# UNITED STATES PATENT AND TRADEMARK OFFICE

<b>Office Action Summary</b>	<b>Application No.</b> 10/731,868	<b>Applicant(s)</b> SINGHAL ET AL.	
	<b>Examiner</b> William H. Matthews (Howie)	<b>Art Unit</b> 3774

## **DETAILED ACTION**

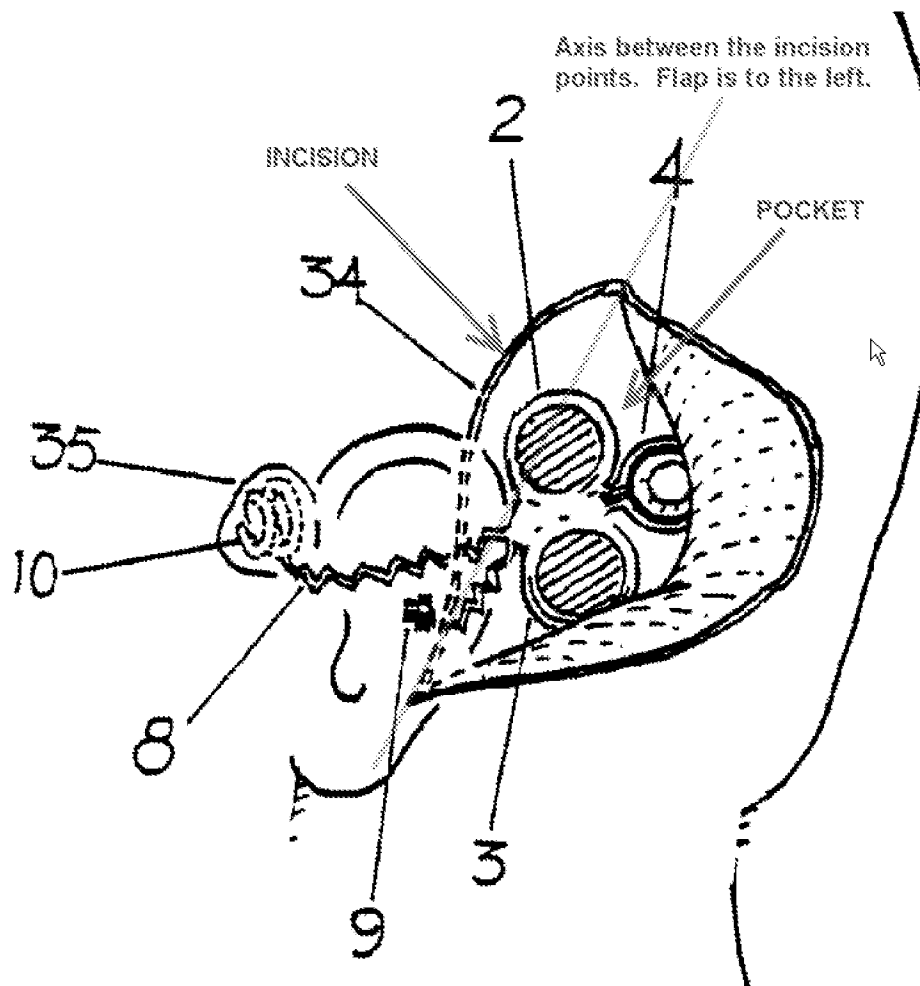
With respect to claims 1, 26, and 28, Applicant argues Berrang and Berrang Application fail to show or suggest a pocket as claimed. Examiner disagrees and provides Figure 3 of Berrang below with notations showing how the figure is interpreted.

The S-shaped incision 34 is shown. The flap would exist to the left of the axis between the start and end points of the S-incision. Inherently, this flap is connected at a fold (the incision S-line). The pocket is to the right of the axis (i.e. behind the incision and flap). Applicant acknowledges that a flap is present in each Berrang invention (Remarks, paragraph 4 of page 4 and paragraph 1 of page 5). Thus if a flap is present, a fold is present along the incision line. This flap is then pulled back to reach the state shown above. Thus it is improper of Applicant to consider the fold shown in figure 3 to the right of, or behind, the implant as the only fold in Berrang. Clearly there is a separation as the implant above occupies the separation.
